HISTORIC PRESERVATION BOARD STAFF REPORT

46 Marine Way

Meeting	File No.	Application Type
June 3, 2026	HP-544-2026	Certificate of Appropriateness, Demolition, Relocation, Variances, & Waivers

EXISTING EAST ELEVATION
1/4" = 1'-0"

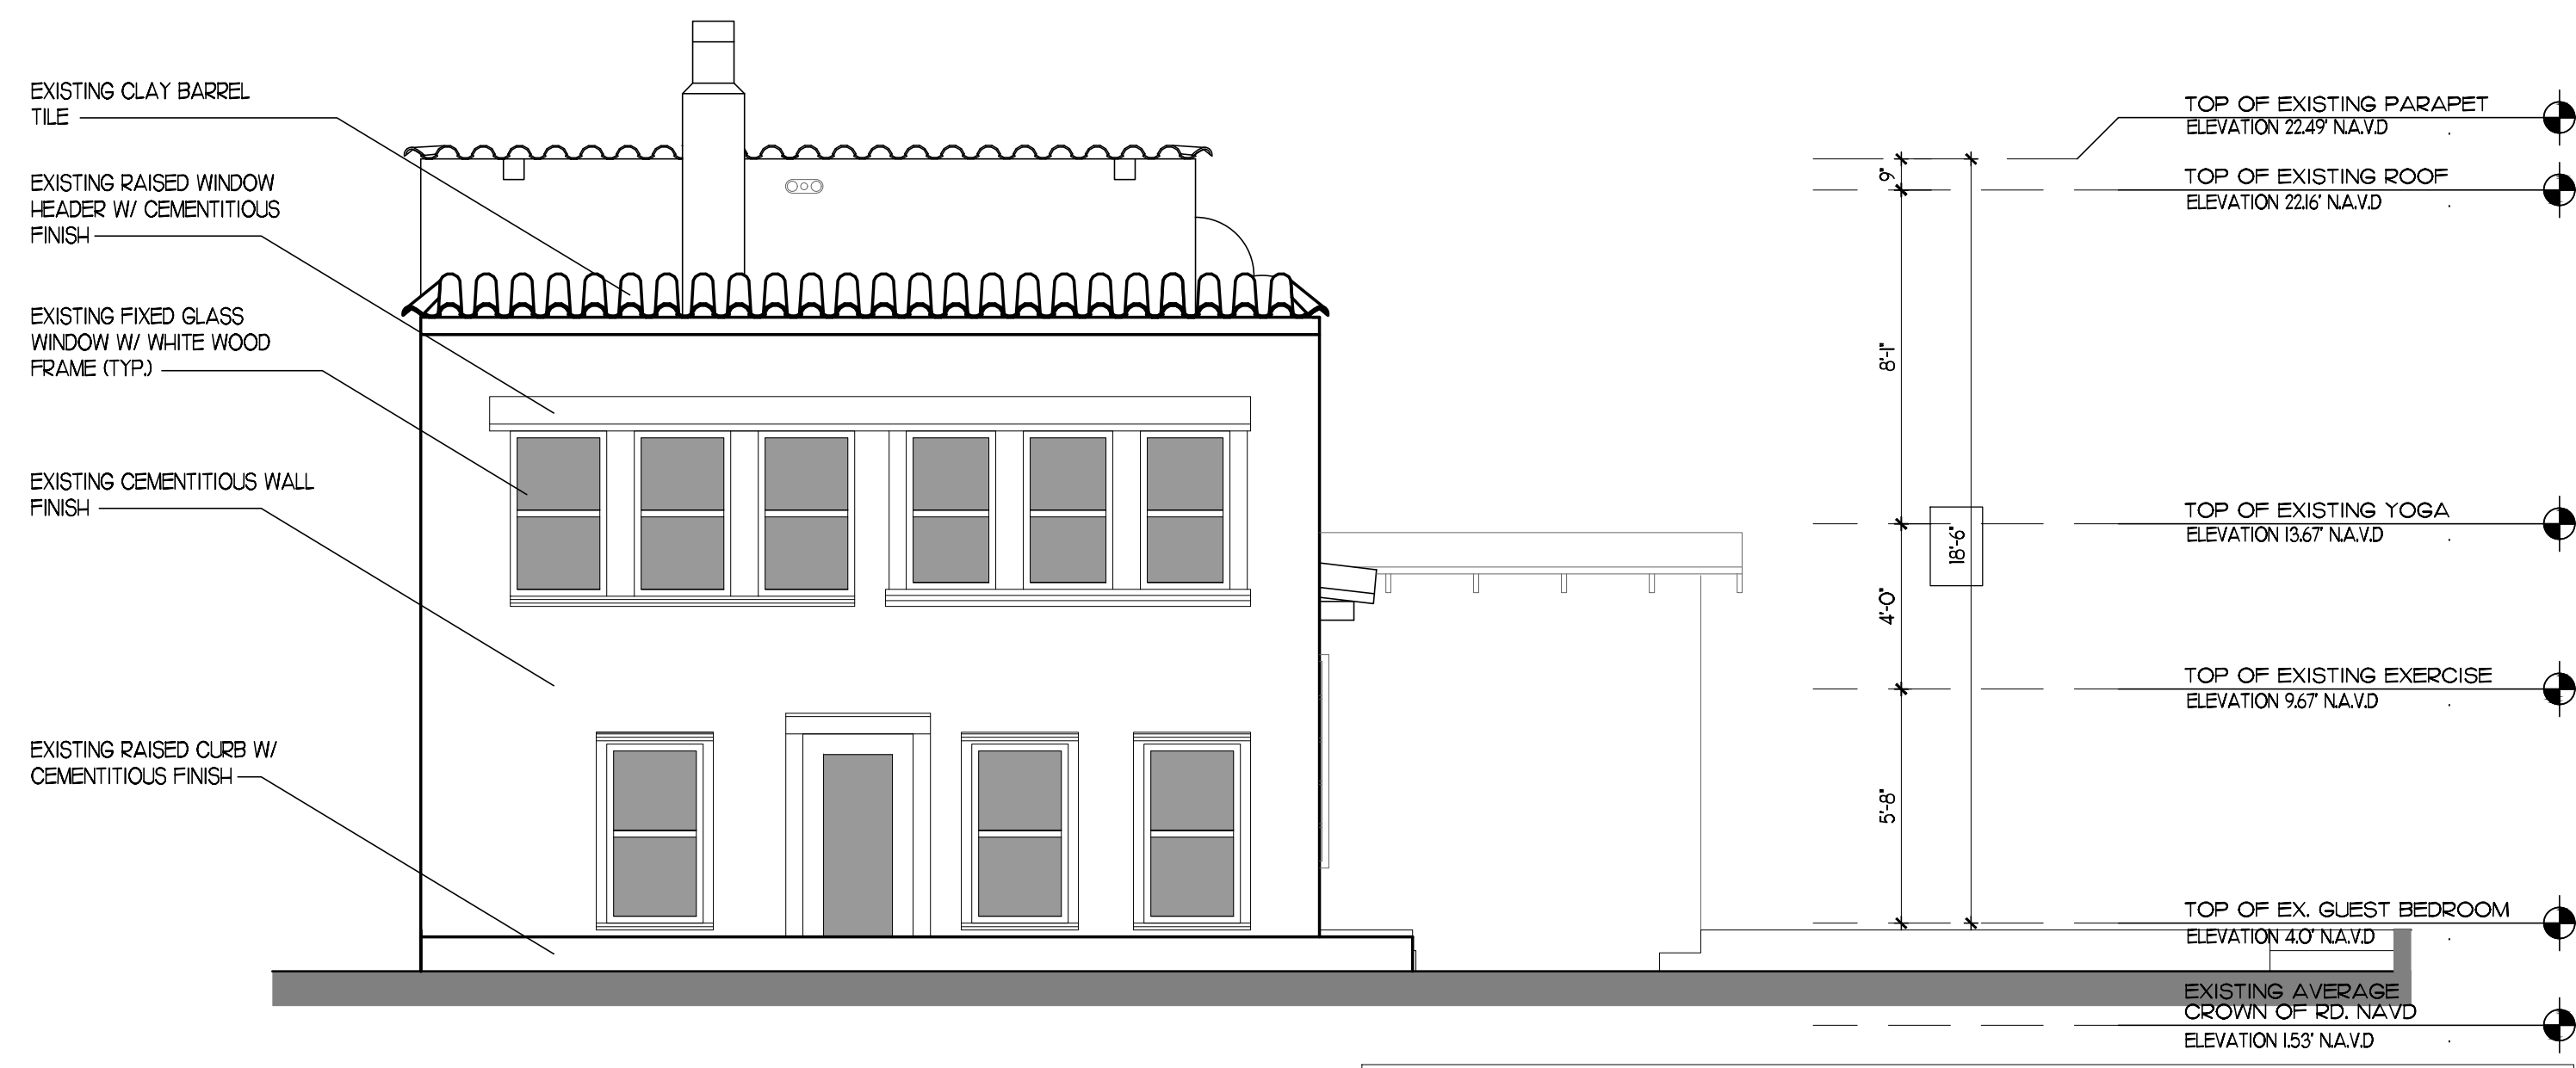
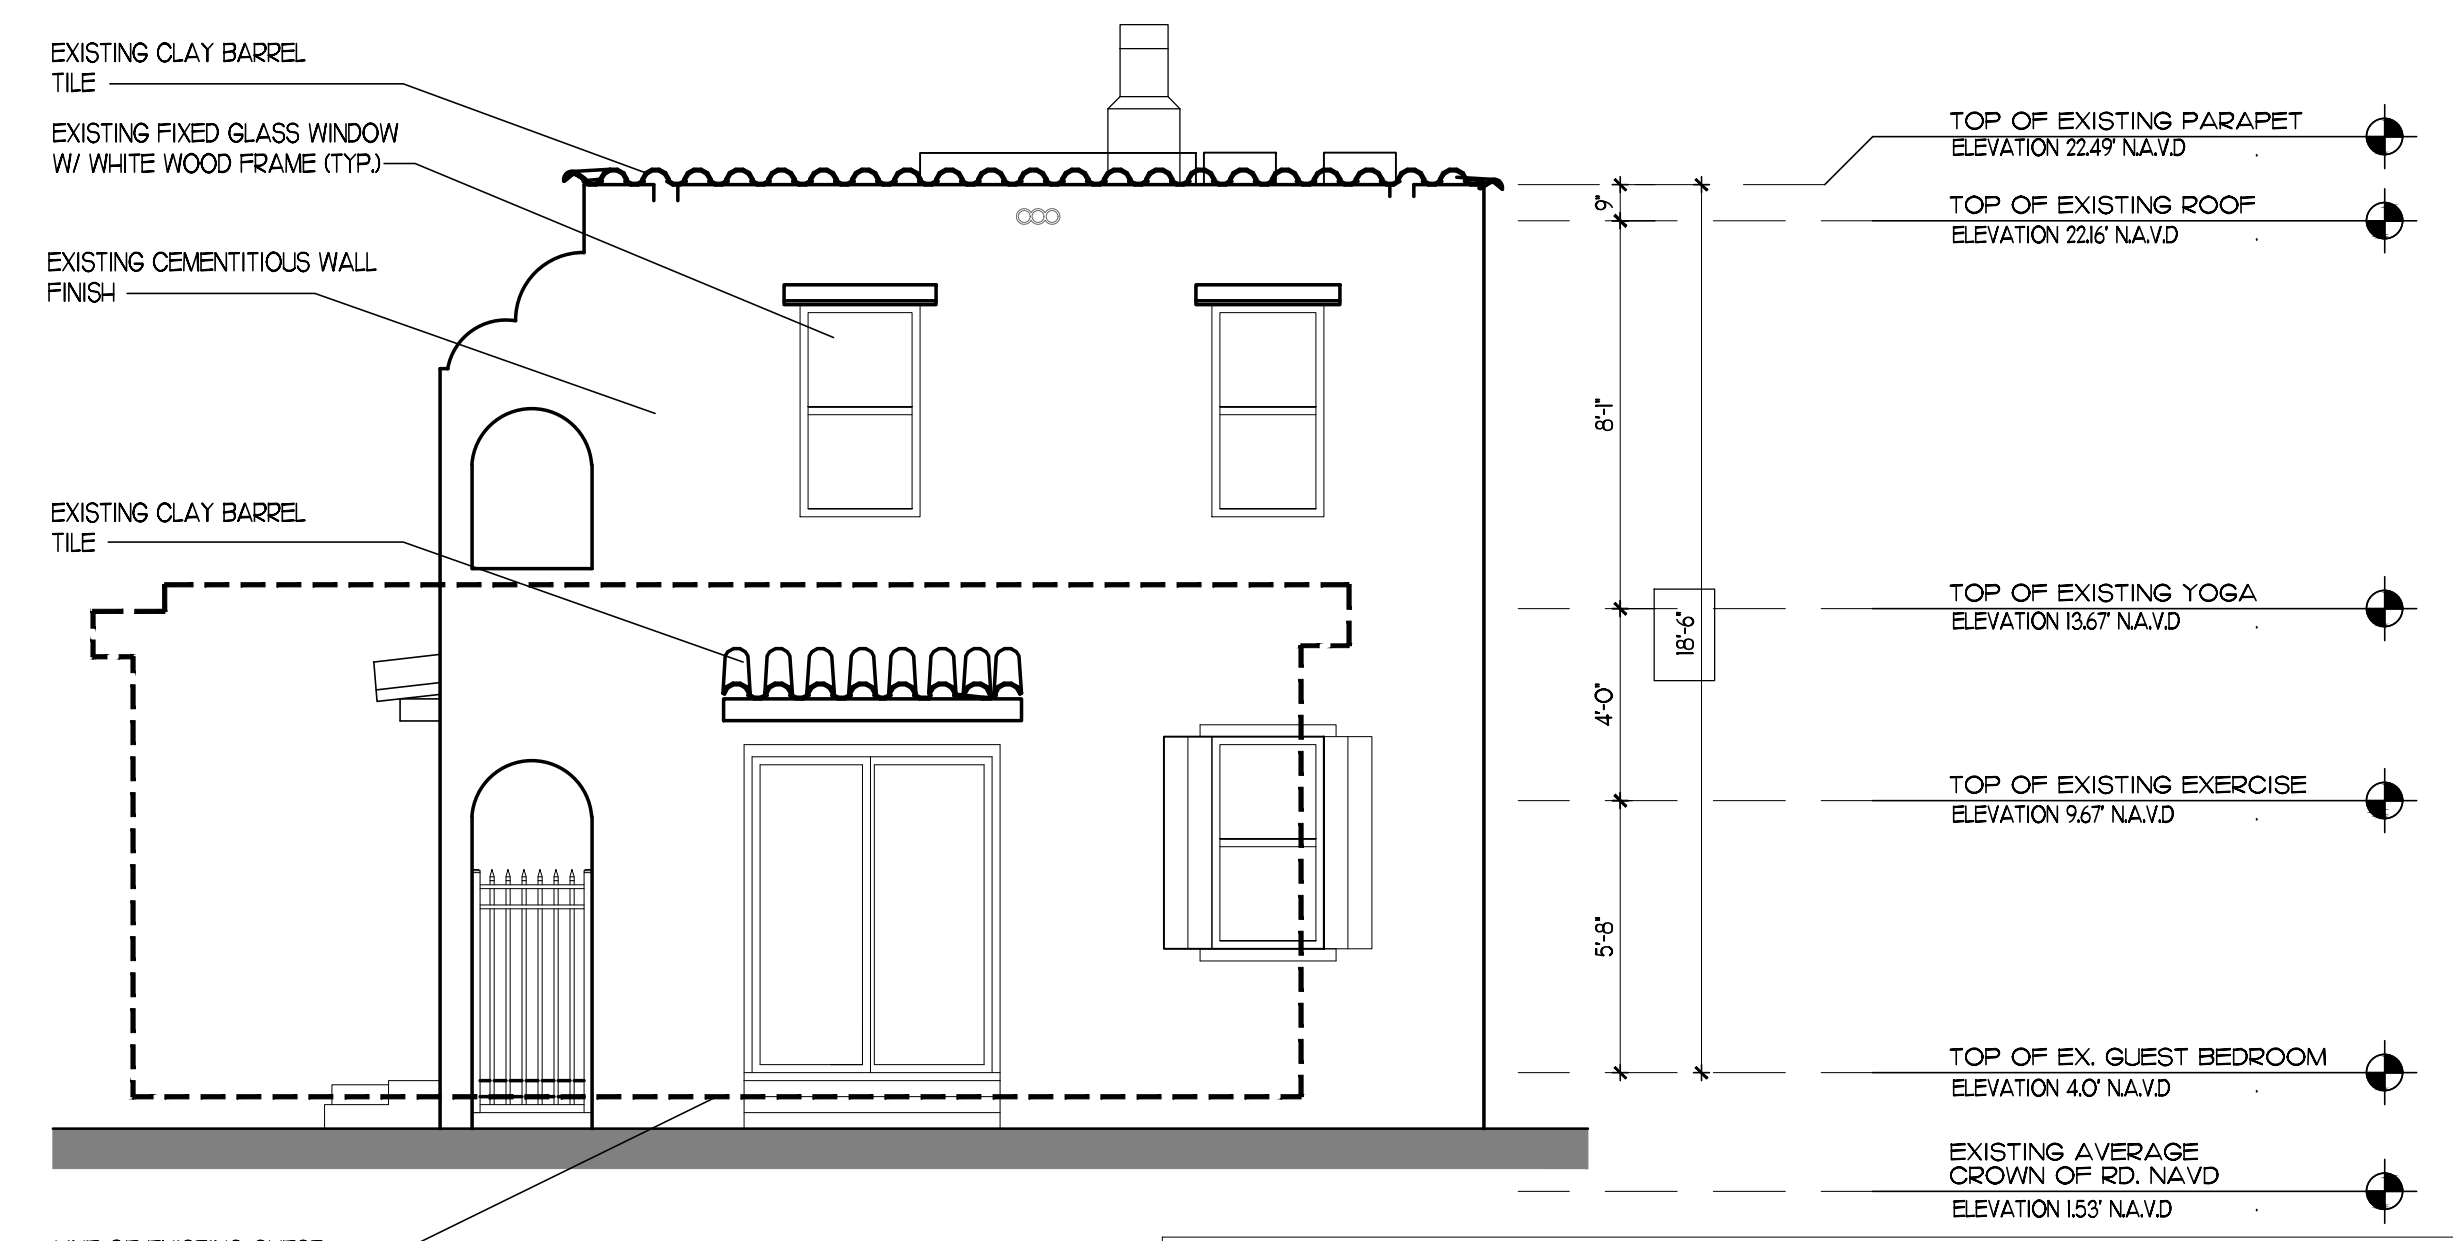
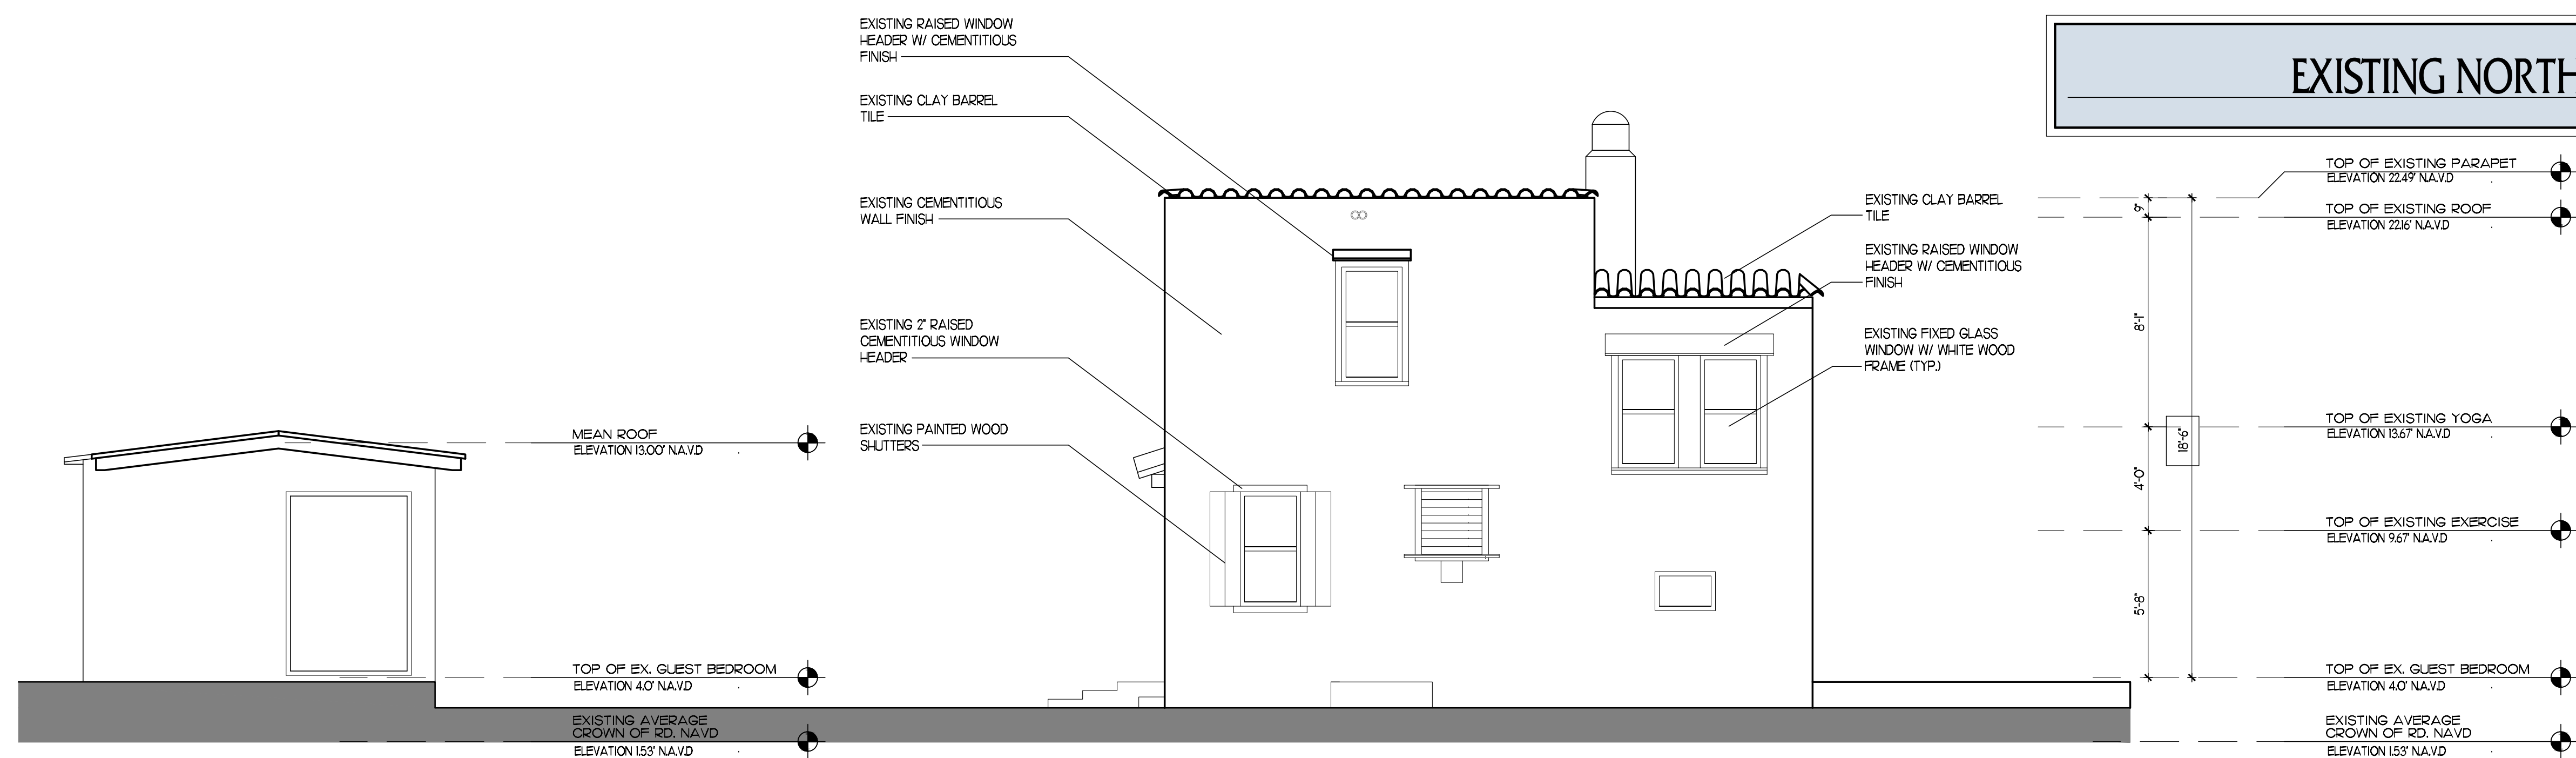
2. That the existing elevations be revised to indicate existing finished floor elevations (both interior finished floor elevations for the first floors) and top of floor values not “top of existing exercise” as such does not delineate a floor measurement value (first floor, second floor, mezzanine, etc.);

3. That the existing architectural elevation plan sheets are revised prior to site plan certification to indicate and illustrate all existing building architectural elements and materials including but not limited to, coral, scuppers, gutters, etc. and that such elements and materials be labeled as “existing to remain” on the proposed elevations;
